EA 96-354

SUBJECT: MEETING SUMMARY - PREDECISIONAL ENFORCEMENT
CONFERENCE BRUNSWICK - DOCKET NOS 50-325 AND 50-324

Predecisional Enforcement Conference Environmental Qualification Program

Carolina Power & Light Company
October 21, 1996

Hydrogen Water Chemistry

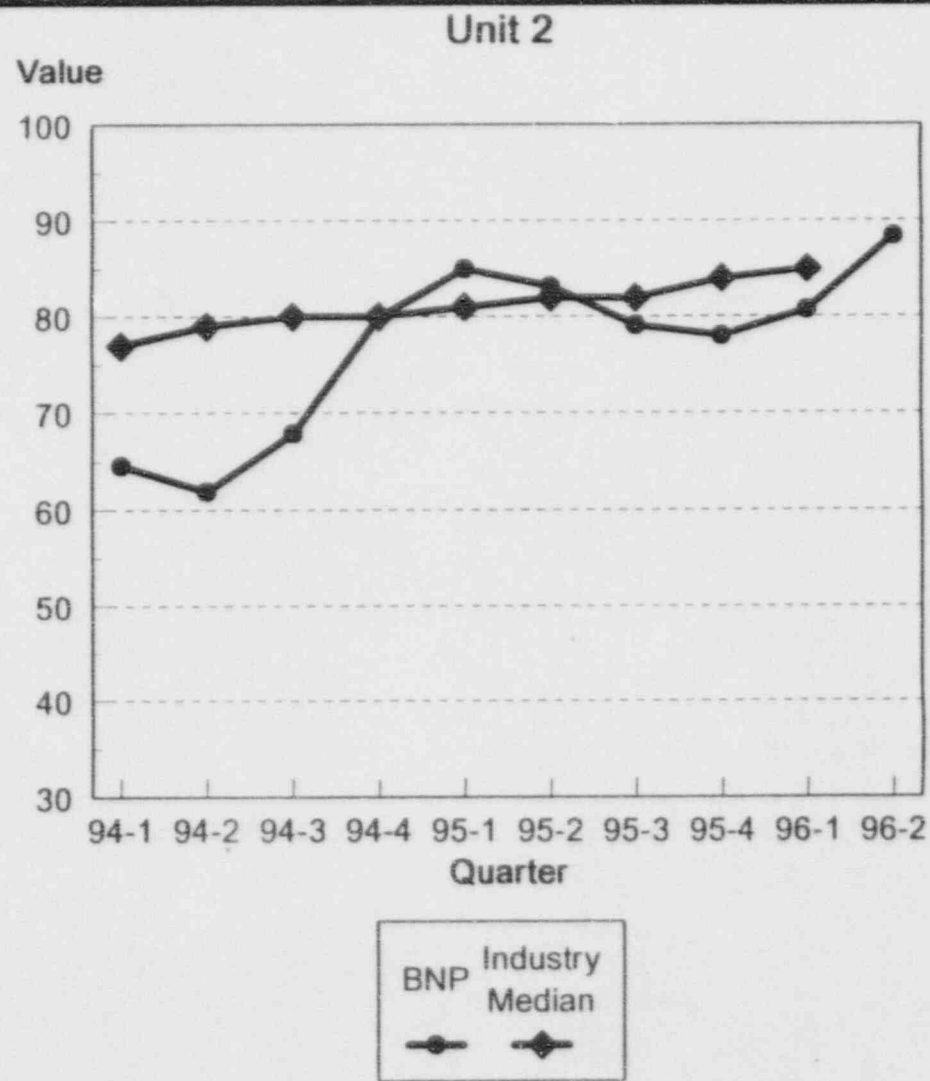
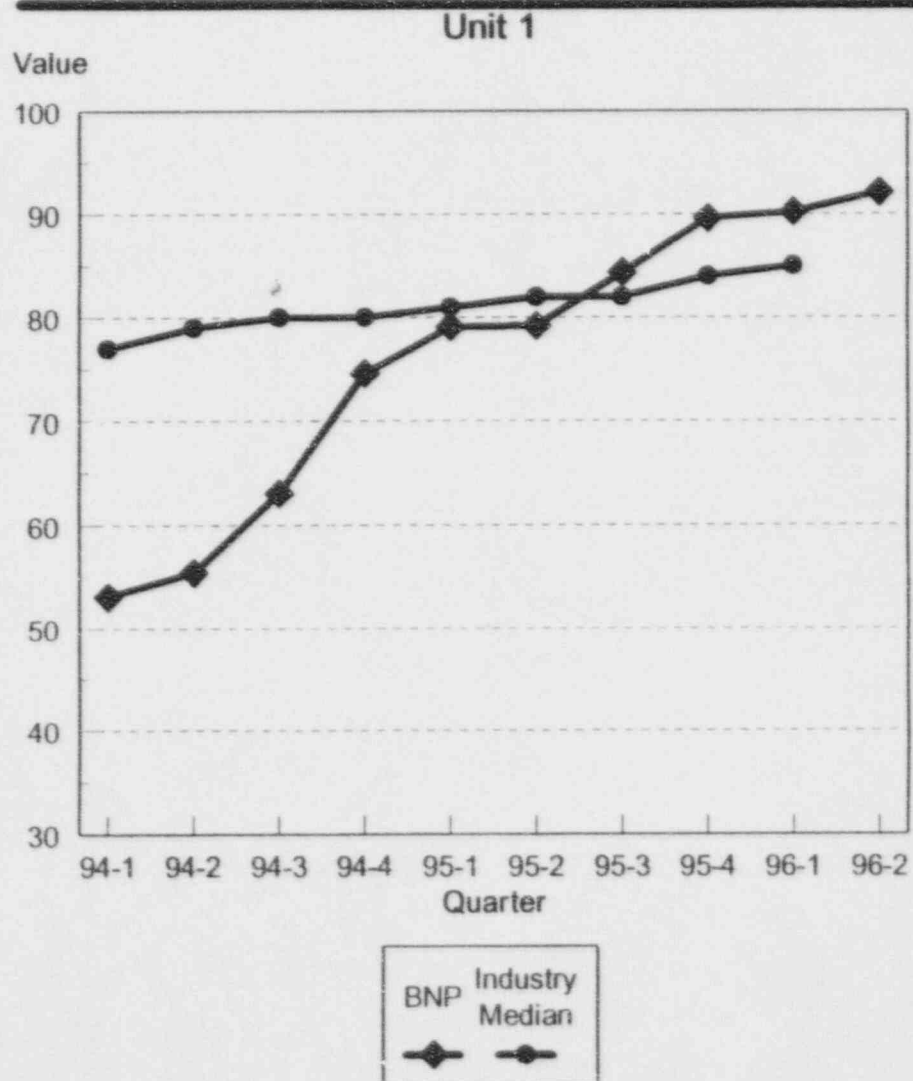
- The modification installing HWC did not assess impact on EQ program
- ESR 94-0052 determined there was no short term impact on EQ
- Effects of HWC have been factored into current radiation profiles
- QDPs were validated against latest revision of the RBER
- Must Update QDPs, DBDs, UFSAR
